**Planning application no. LCC/2014/0096**

**by Cuadrilla Bowland Limited to drill at**

**Preston New Road, Lancashire:**

**Objection on grounds of geology and hydrogeology**

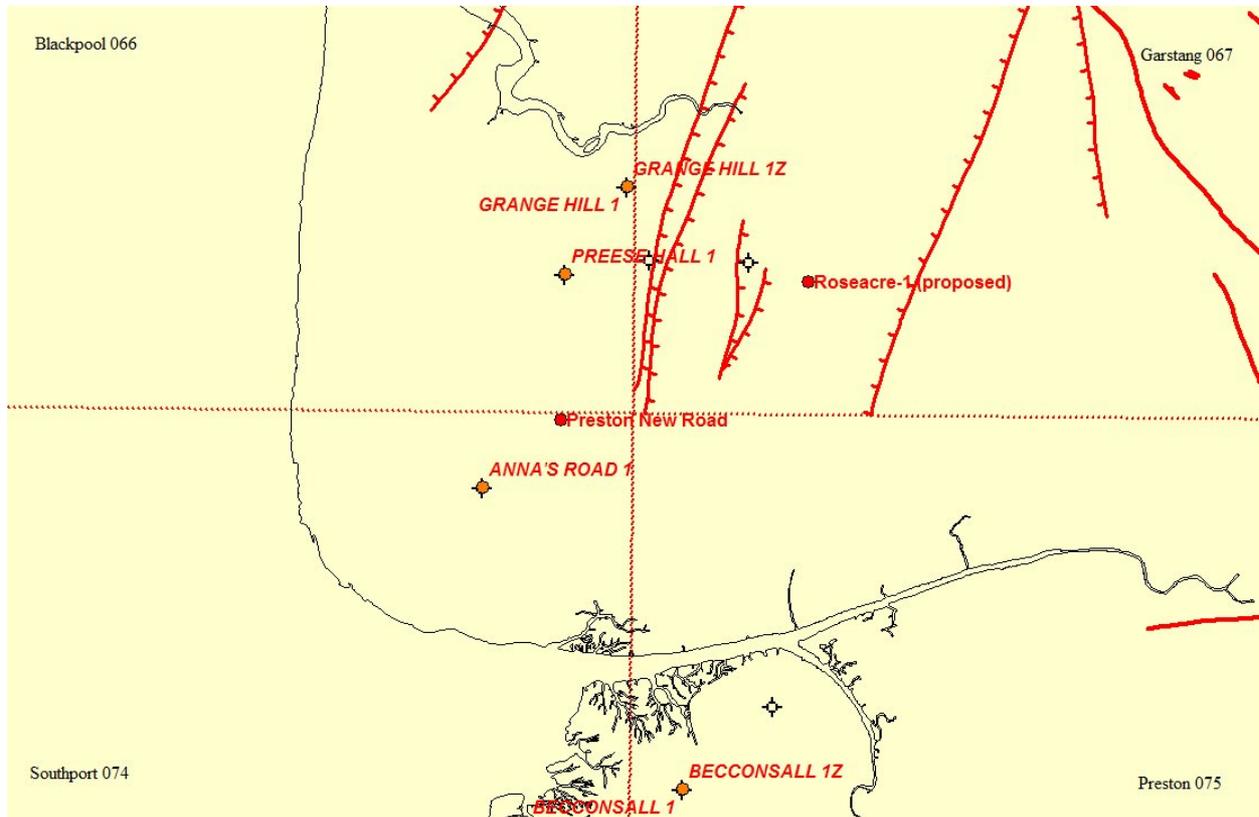
Thus in Figure 11.1 (Hydrogeology summary), as an example of the first dependency above; two parallel faults, one of which is labelled the Thistleton Fault, are shown on the published BGS solid geology maps as dying out in the centre of the picture about 2 km east of the site. But this is not because they actually die out, as Cuadrilla's own interpretation of its 3D results shows. The apparent termination of the faults at the western and southern edges of the Garstang 1:50,000 sheet 67 (published in 1990) is an inconsistency due to the fact that the three adjacent sheets were mapped at different epochs (Fig. 3.1). The intersection of the four sheets is 1.9 km ENE of the proposed drillsite. That is why the faults apparently die out to the south. In fact the newest mapping is of the Preston sheet 75 (published in 2012), which shows major faults, but these faults have not yet been added to the BGS digital database used by Cuadrilla.

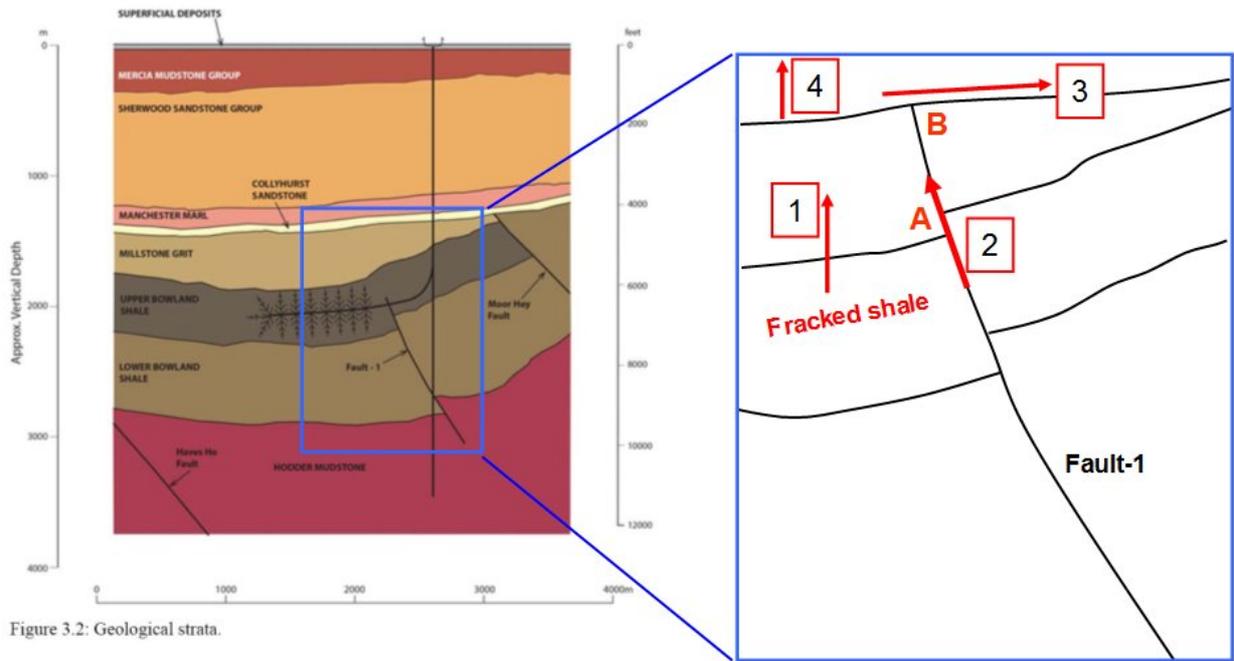
We now turn to the E-W geological cross-section presented by Cuadrilla, passing through the proposed drillsite. It is reproduced in the left-hand side of Figure 5.2. The right-hand side of the figure shows an outline of the geological structure within the blue rectangle on the left. I have altered the geometry of the so-called 'local' Fault-1 by extending it upwards with a similar magnitude of throw (displacement) of around 100 m as Cuadrilla has interpreted it at the base of the Upper Bowland Shale, based on my discussion in section 3.3. above. This alteration is at point A in the diagram. I also extend it up to the unconformity (point B) at the base of the Permian Collyhurst Sandstone (the thin yellow layer in Fig. 5.2). This is justifiable because the fault can then be presumed to be Hercynian in age (post-Carboniferous, pre-Permian) just like the Moor Hay Fault, shown on the right of the Cuadrilla diagram.

The right-hand side of Figure 5.2 shows the possible flow paths from the Upper Bowland fracked shale, labelled as follows (numbers within red rectangles):

More crucially, the Manchester Marls, at only 160 m thick, will not provide a viable cap-rock. In any case, flow paths 1 and 2 (Fig. 5.2) permit rapid migration along the highly permeable Collyhurst Sandstone below. The drillsite is 7 km from the Woodsfold Fault, which, I have argued, will be transmissive. It is therefore feasible that flowback and/or produced water and gas from the fracking of the Upper Bowland Shale at Preston New Road will pass into the SSG, the important Principal Aquifer, lying to the east side of this major fault.
